Great River Energy Responses to EA Questions

Re: **Responses of Great River Energy to Energy Environmental Review and Analysis
Questions for Development of Environmental Review, Questions 1-9**

In the Matter of the Application of Great River Energy for a Route Permit for the
Palisade 115 kV Project in Aitkin County, Minnesota

Docket No. ET2/TL-15-423

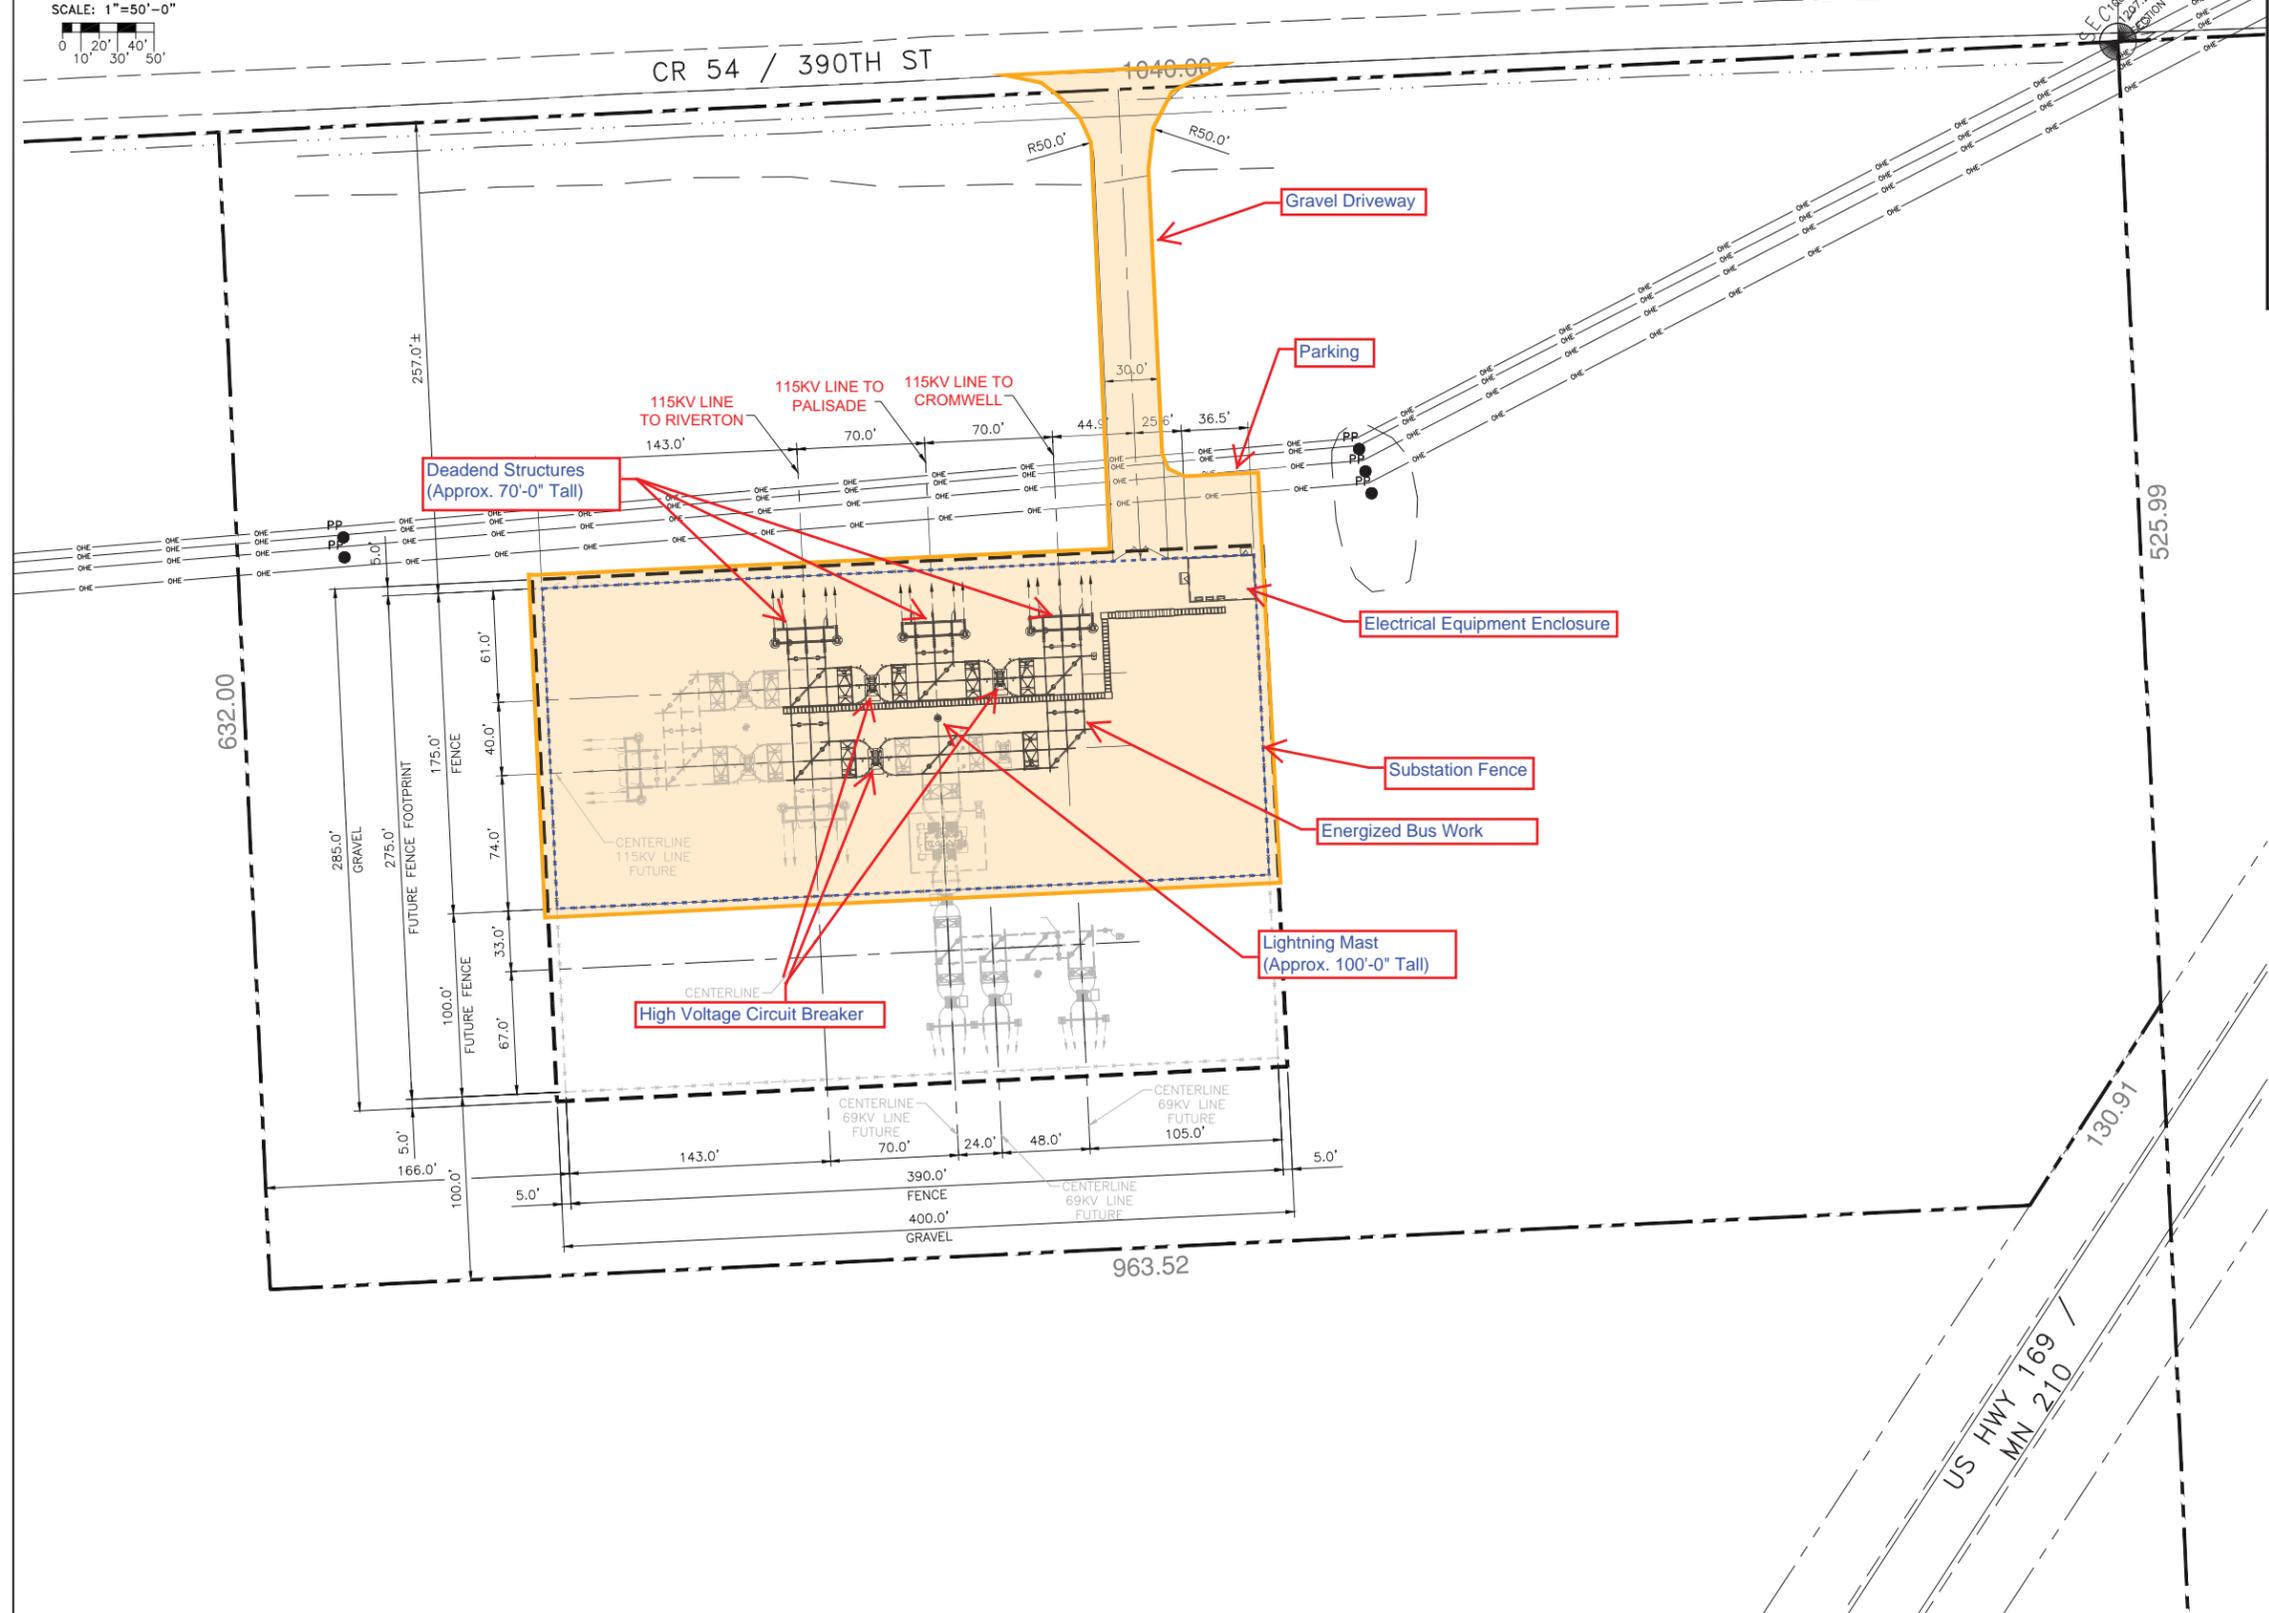
Other than the description of the fenced area of the proposed Rice River Breaker Station on p. 7-8 of the Application, there is little indication of what the breaker station will contain or look like. Please provide additional description including:

- Description of the current land use at the proposed breaker station location
- Description of equipment (type of equipment, relative height of major equipment) at the breaker station
- Description of lighting
- Description of fence including height and provisions for ingress/egress to the facility.
- Description of any cleared area to be maintained outside of the fenced area, such as for parking.
- Description of construction
- Description of operations and maintenance procedures
- Photo or illustration of a similar breaker station

- This property is presently being used for agriculture.
- The equipment at this site will consist of steel structures, high voltage circuit breakers, aluminum buswork and an electrical equipment enclosure. The steel structures will be galvanized and range in heights from 7'-0" to 100'-0". There will be one 100'-0" shield mast which will protect the breaker station from lightning strokes that would have an adverse effect on the electrical delivery system. There will be three two-legged 70'-0" tower structures to tie the transmission lines into the breaker station. There will be three circuit breakers to protect the system and provide a means for switching. The energized aluminum buswork will be 14'-0" and 22'-0" tall as required. There will be one 24' x 36' x 12' electrical equipment enclosure which will house the relaying and controls for the site.

- The lighting at this site will be limited to entryway illumination above the doors on the electrical equipment enclosure.
- The fence will be chain link construction with a security wire cap. The chain link will be 7'-0" tall with a 1'-0" security wire top. There will be one 30'-0' gate for drive access to the site. Personnel access will be through the electrical equipment enclosure.

- This site will have a 260'-0" maintained drive with an approximately 2,000 ft² parking area near the breaker station fence. Surfacing will be gravel.

- Site construction will consist of a metal clad neutral painted equipment enclosure with galvanized structural steel members making up the breaker station yard. The yard surfacing will be crushed granite stone. The equipment required for construction will be service trucks, bucket trucks, man lifts, and a crane for one day to set the electrical equipment enclosure.

- See site examples attached.
